Approved based on notes located on floor plan/last page.

STRUCTURAL DESIGN

ENCLOSED BUILDING

MAXIMUM 30'- 0" WIDE X 20'- 0" EAVE HEIGHT-BOX EAVE FRAME AND BOW FRAME

IRST FLOOR PLAN

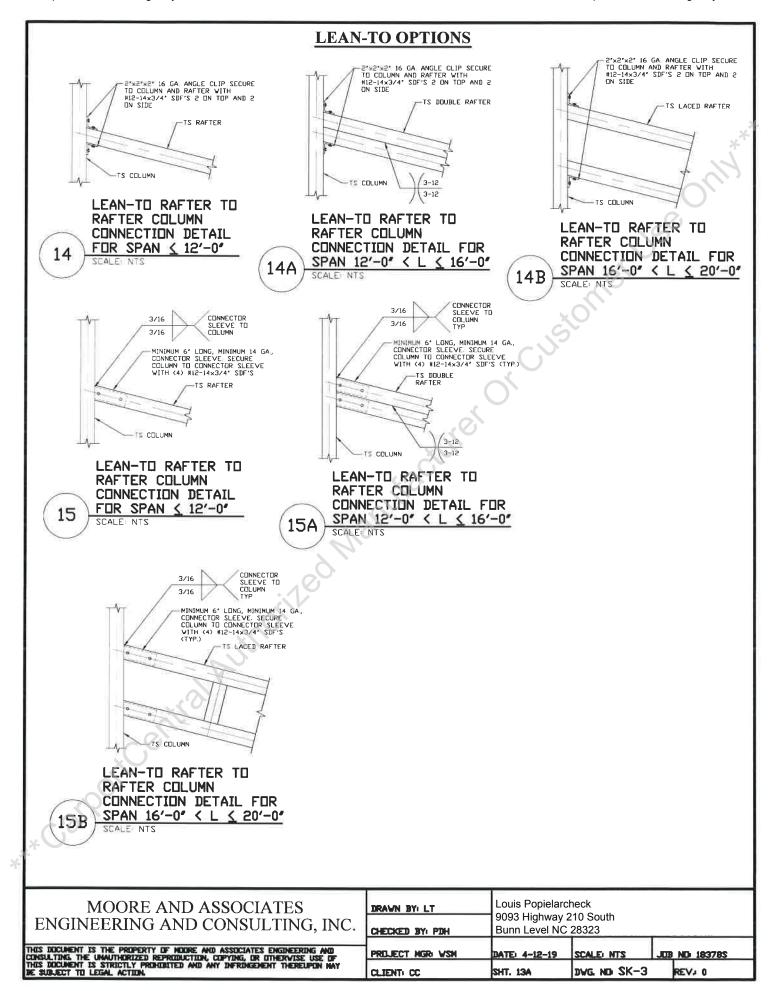
MIN. ATTIC ACCESS SHALL BE
PROVIDED BY BUILDER AND
LOCATED ON SITE. WALL/CEILING HGT. WALL AND CEILING HEIGHT NOTES ARE BASED ON NOMINAL WALL SIZE. KNEE WALL HEIGHT LABELS FOR WALLS UNDER RAFTERS ASSUME AN EXTRA 2" FOR FURRING (IN HEATED SPACES) Wall and ceiling must be 1/2 inch drywall for fire separation, or wall must extend to roof deck with 1/2 inch drywall. **GARAGE** FOR INSULATION. THE WALL
HEIGHT REFERS TO THE HGT.
FROM THE FLOOR DECKING TO
THE BOTTOM OF THE FURRING. Floor must slope toward garage door per code 14/0×12/0 GARAGE DOOR
